**+MEMORANDUM**

**TO:** Historic Preservation Board  
**FROM:** Merrilyn C. Rathbun, Fort Lauderdale Historical Society  
**SUBJECT:** Agenda for December 1, 2014  
**DATE:** Nov. 24, 2014

<b>Case</b>	H14014	<b>FMSF #</b>	
<b>Applicant</b>	<i>Hansen Associates Architecture &amp; Design</i>		
<b>Owner</b>	Michelle Grosman		
<b>Address</b>	1016 Waverly Road		
<b>General Location</b>	Approximately 117 feet east of the SW 11 <sup>th</sup> Avenue and Waverly Road intersection.		
<b>Legal Description</b>	LOTS 1,2,3,4,5,6 AND THE EAST HALF OF LOT 7 BLOCK 101 "WAVERLY PLACE" PLAT BOOK 2 PAGE 19 OF MIAMI-DADE COUNTY, LOCATED IN BWD COUNTY, FL, LESS AND EXCLUDING THE WEST 5 FEET OF THE EAST ON-HALF OF LOT 7, BLOCK 101 OF WAVERLY PLACE.		
<b>Existing Use</b>	Residence		
<b>Proposed Use</b>	N/A		
<b>Applicable ULDR Sections</b>	47-24.11.C.3.c.i, 47-24.11.C.4.c		
<b>Request(s)</b>	Certificate of Appropriateness for Demolition 1. Demolition of an existing single-family residence.

Figure 1. From the applicant's plans; street facing elevation for the proposed project.

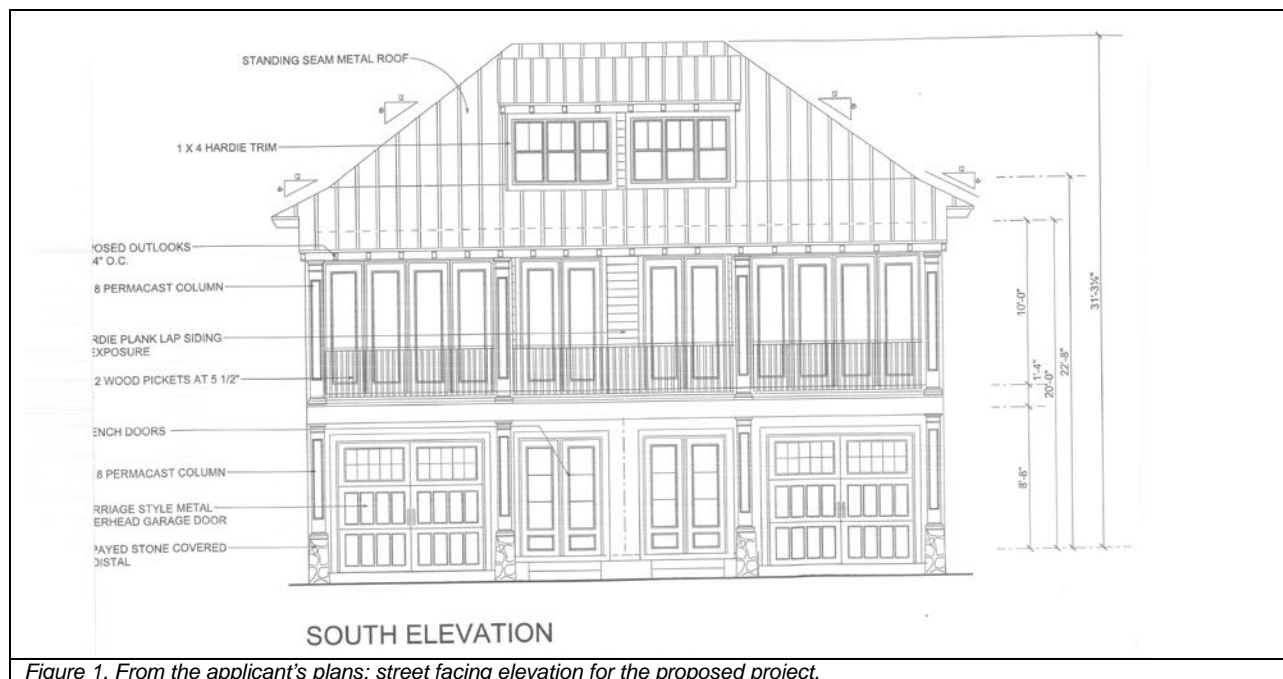
The proposed plan calls for the standard front, rear and side setbacks. The historic apartment building to the west of the lot, is built up to the lot line, which means that there will be just 5 feet 8 inches between the historic building and the new construction. The new building will loom over the one story historic complex.

The façade of the new residence has street facing garage doors, one at each corner. There is a full width second floor balcony which is supported by pillars, which gives the effect of a porch on the ground floor and diminishes the impact of the front facing garage doors.

g) <i>The roof and shape of a building shall be visually compatible with the buildings to which it is visually related.</i>	CONSULTANT RESPONSE The proposed project's massive hip roof is not visually compatible with the low to medium rise gable roofs and parapeted flat roof of the adjacent buildings on the street.

i) <i>The size of a building, the mass of a building in relation to open spaces, the windows, door openings, porches and balconies shall be visually compatible with the buildings and places to which it is visually related.</i>	CONSULTANT RESPONSE The proposed project is dissimilar in size, form and massing to adjacent buildings on the block

As it is presented, the applicant's proposed plan is inappropriate, and unless the plan is modified, the requested COA should be denied.

Figure 1. From the applicant's plan.

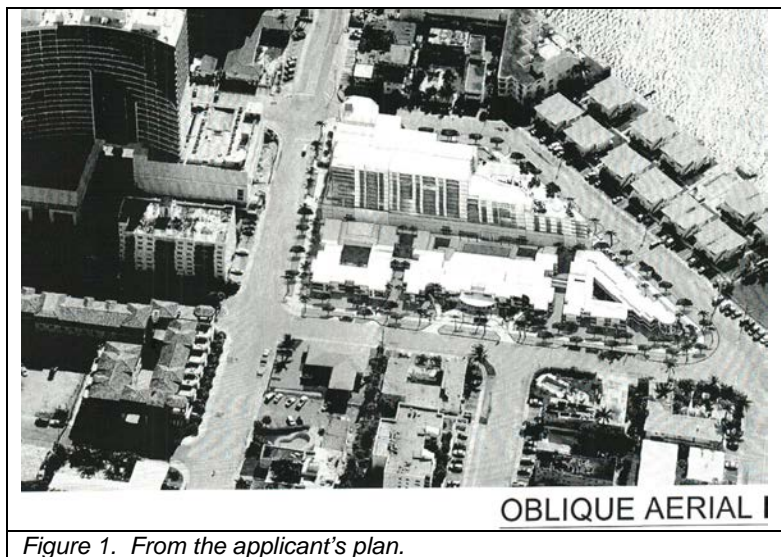
Today the applicant is presenting plans that increase the size of his condo building from 74 units to 128 multi-family residential units. The height of the 12 story section will not change but the mass of the section will be increased; the north elevation of the 12 story section is to be pushed forward so that it is in line with the north elevation of the 8 story section and the north wall of the parking deck. This alteration could cause a shadow effect on the historic structure. The applicant's consultant included shadow studies for the project in his narrative.

ULDR Section 47-24.11.C.3.c.i	Consultant Response
a) <i>The effect of the proposed work on the landmark or the property upon which such work is to be done;</i>	CONSULTANT RESPONSE The only change, visible from the exterior to the historic hotel complex is the addition of the canopy to the entrance. The design of the canopy has been modified to lessen its impact on the historic structure. The increased mass of the condo building will have a greater shadow impact on the historic resource

b) <i>The relationship between such work and other structures on the landmark site or other property in the historic district;</i>	CONSULTANT RESPONSE The proposed condo building is sited very close to the historic hotel building and could have some adverse visual impact on the resource.

The related new construction is differentiated from the old, but it is much larger in terms of massing size and scale.
